COMMENTS
on the measurement methods of hydrocarbons emissions
according to Regulation 83.06
(by the expert from Poland)

Fig. 1. Flow of the calibration gas through the cutter

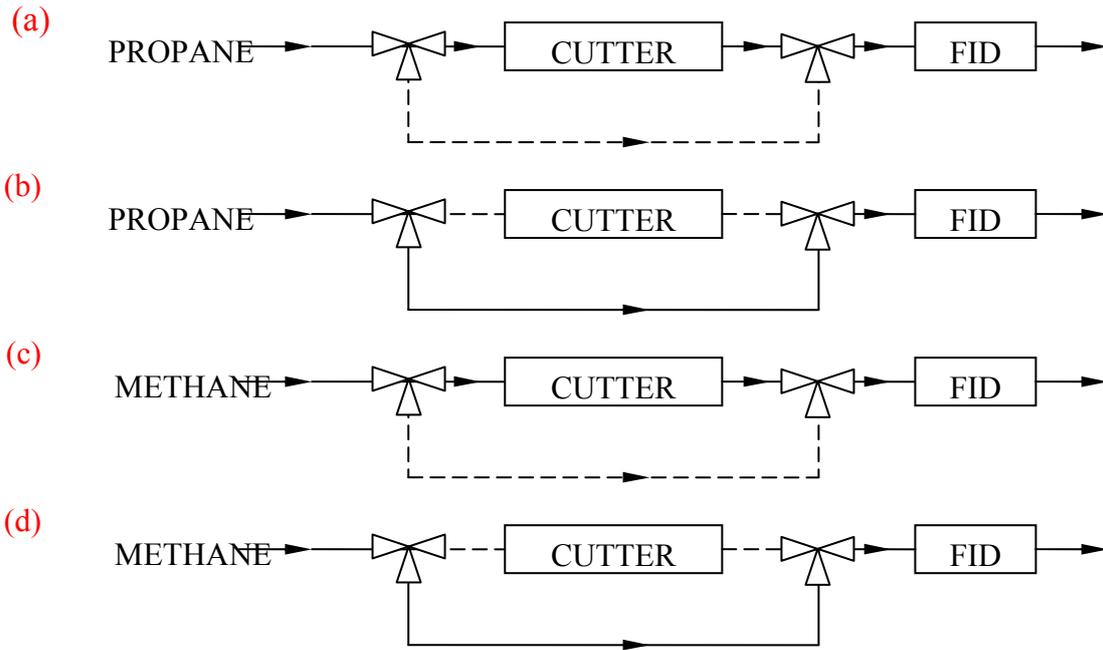
As regards LDV, it is clearly specified in Regulation 83.06 (and Regulation 692/2008) that the FID analyser should be calibrated with methane for measurements of c_{HCW}^S ("The analyser shall be either a gas chromatograph combined with a flame ionisation (FID) type or a flame ionisation (FID) with a non-methane cutter type, calibrated with methane gas expressed equivalent to carbon atoms (C1)"). However, it is not specified whether the calibration gas – methane – should pass through the cutter or should bypass it.

- it is simplified as two important factors affecting measurement results: the cutter efficiency for methane E_M and the cutter efficiency for ethane E_M are not taken into account,
- the configuration of the measurement system (whether the calibration gas – methane – passes through the cutter or bypasses it) is not clearly specified.

(iii) The method of methane and NMHC concentration measurement by means of non-methane cutters (NMC) specified in Regulation 83.06 and Regulation 692/2008 for LDV needs correcting. It is proposed to apply the method described above (Table 1) identical to the amended method laid down in GTR No. 4 and Regulation 582/2011 for HDV. It has an advantage that it is possible to use analysers and NMCs having different parameters R_{FCH_4} , E_M and E_E for testing and test results are less dependent on the quality of the test equipment. It is proposed to specify, as in GTR No. 4 and Regulation 582/2011, two methods of FID calibration (Fig. 1):

- with propane, propane bypassing NMC (configuration (b));
- with methane, methane passing through NMC (configuration (c)).
